Review of Wagga Wagga Floodplain Risk Management Study & Plan

Final Report

Date: August 2021

Figure 3-2 Histogram showing the distribution of difference in elevations between the 2009 LiDAR and FRMS&P 2018 values for residential properties

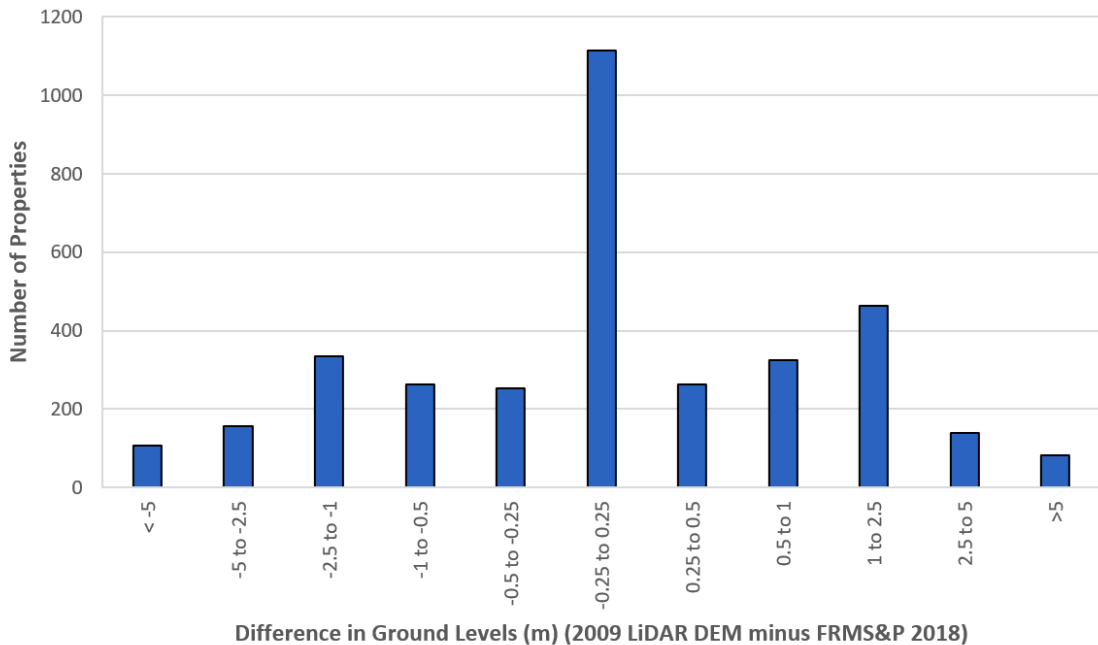
A histogram showing the distribution of differences in elevation between ground levels used within the FRMS&P 2018 Residential Damage Spreadsheet and ground levels extracted from the 2009 LiDAR DEM at the quoted X and Y coordinates is provided in Figure 3-2. This histogram quantifies the spread and magnitude of the variation and helps to understand the potential influence of this issue. For comparison, a similar histogram is also provided in Figure 3-3 for the non-residential properties. Note that the difference refers to the 2009 LiDAR elevation minus the elevation within the damage calculation spreadsheet.

The greater impacts on damage calculations at a property level would occur as a result of the property being newly impacted above ground and/or above floor, or alternatively no longer impacted

above ground and/or above floor. However, the overall impact of this issue across the whole study area may result in a minor net change in total intangible damages or alternatively, may result in a significant net change in total tangible damages.

Figure 3-6 North Wagga Levee breach locations (shown as orange polygons)

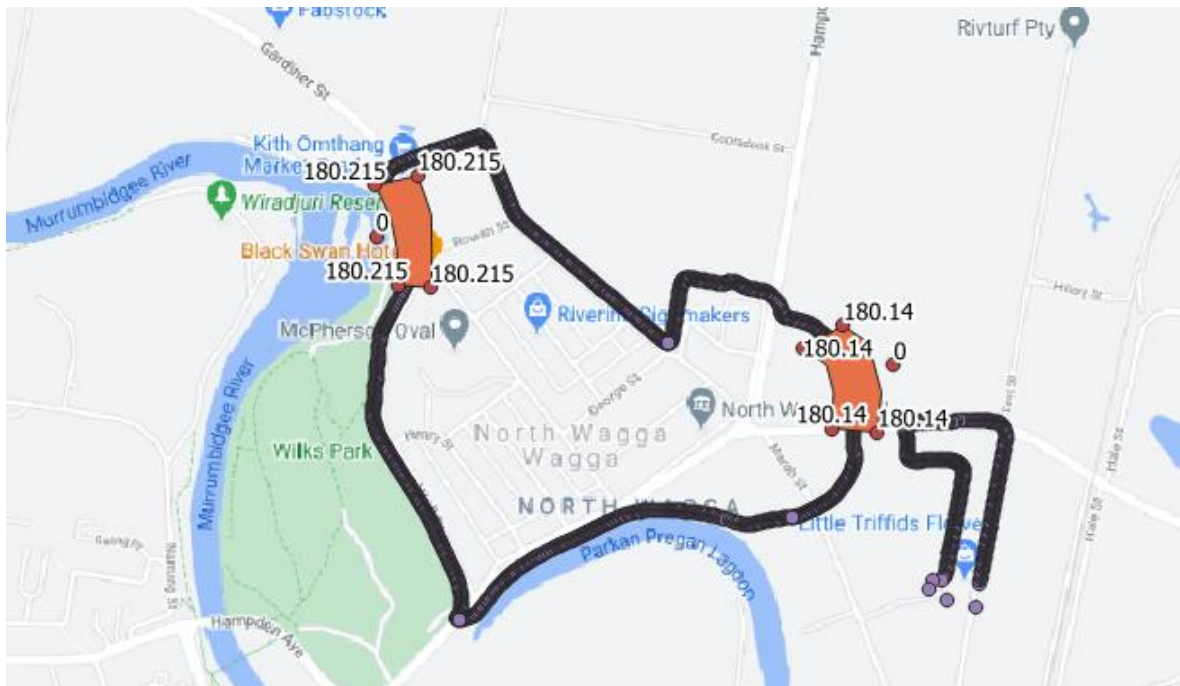
The breach of the existing North Wagga Levee is modelled by reducing a 100 m section on each side of the levee (upstream and downstream) to a level halfway between natural surface and the existing level of protection to allow controlled failure to occur. The breach is modelled in TUFLOW as a “variable Z shape”. Essentially, TUFLOW 2D model topography is varied over time to represent embankment failure when the water level reaches a specified height (in this case the design level of protection) at a specified trigger location (refer modelled breach locations in Figure 3-6).

Under North Wagga Levee upgrade scenarios (i.e. Option L3(A-C) and L4(A-C)), the North Wagga Levee was reported within the FRMS&P 2018 to be modelled using the same approach as for the Wagga CBD Levee (i.e. described above) because the upgrades would include formal spillway designs. However, it is noted that the report does not define what portion of freeboard is removed from the spillways and the remaining freeboard that has been modelled. Contrary to what was reported, the North Wagga Levee upgrade Option L4(B) was found to be hydraulically modelled based on a similar approach as the modelling of the existing scenario. That is, a breach was modelled by reducing a 100 m section on each side of the levee (upstream and downstream) to a level halfway between natural surface and the proposed level of protection to allow controlled failure to occur. A levee freeboard of between 0.3 and 0.6 m was found to be modelled (refer Section 4.3.2).

ID	Recommendation	Issue Type	Issue Significance	Timing
3-5	Correct inconsistency between reported methodology and implementation within the modelling undertaken in relation to freeboard and levee failure for North Wagga. Undertake a sensitivity assessment to re-model reported freeboard and approach and determine impact on results and damages. If sensitivity results are not actionable, as a minimum, update report to be consistent with actual modelling implementation. If actionable, update assessment and all subsequent tasks.	Error	High	FRMS&P 2018
3-6	Undertake a sensitivity assessment of the following scenarios: 1. Full freeboard with no levee failure; 2. Full freeboard with partial (upstream) levee failure.	Gap	Medium	Future

Figure 4-1 Modelled Levee Crest Elevation vs Design Flood Levels

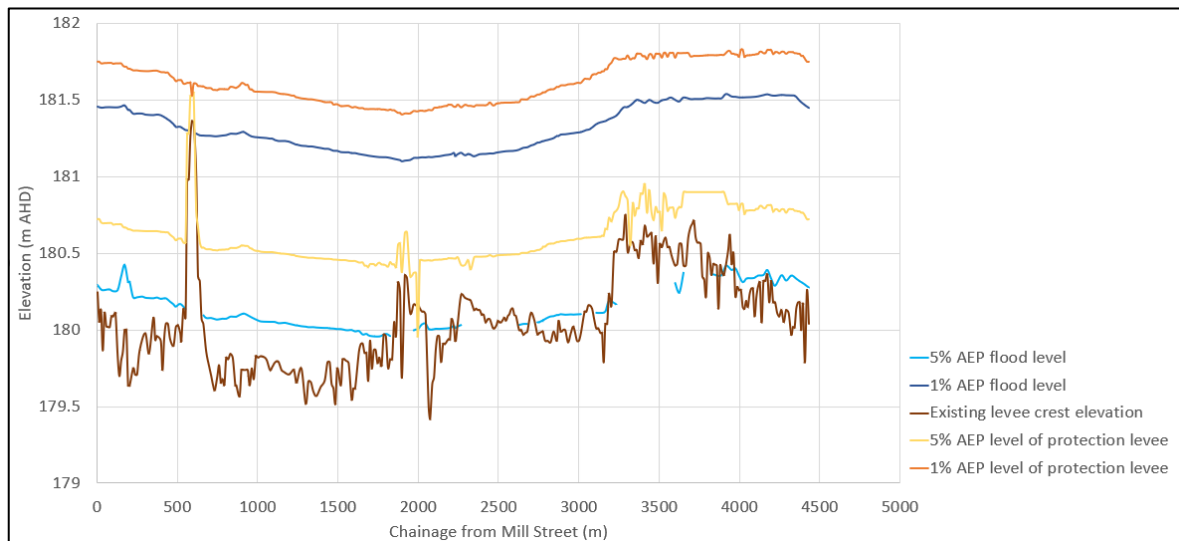
The FRMS&P 2018 report states that a freeboard of 0.75 m was recommended for the North Wagga Levee (Public Works, 2010), however Section 9.3.3.1 of the FRMS&P 2018 states that the proposed North Wagga Levee options include a freeboard of 0.7 m. Within the modelling, the crest of the levee is above the designed AEP flood level, with the freeboard generally varying between 0.3 m and 0.6 m based on a comparison of modelled levee elevations against modelled design flood levels. This is shown in Figure 4-1.

Therefore, neither the recommended nor reported levee freeboard is reflected in the modelling. Furthermore, the modelled freeboard for the no failure scenario was found to be the same as the modelled freeboard for the failure scenario for North Wagga Levee options (albeit without the spillway lowering). This finding is valid for modelling of all North Wagga Levee options but is in conflict with the approach reported in the FRMS&P 2018.

The correct (either recommended or reported) freeboard should be applied to the modelling of levee options and a sensitivity assessment should be completed for all design events to determine the impact of adjusting the levee crest elevations to be consistent with what is reported in the FRMS&P 2018.

ID	Recommendation	Issue Type	Issue Significance	Timing
4-4	Review and correct inconsistency between reported methodology on freeboard and modelled freeboard. This is likely to require updates to the modelling and damage assessment.	Error	High	FRMS&P 2018
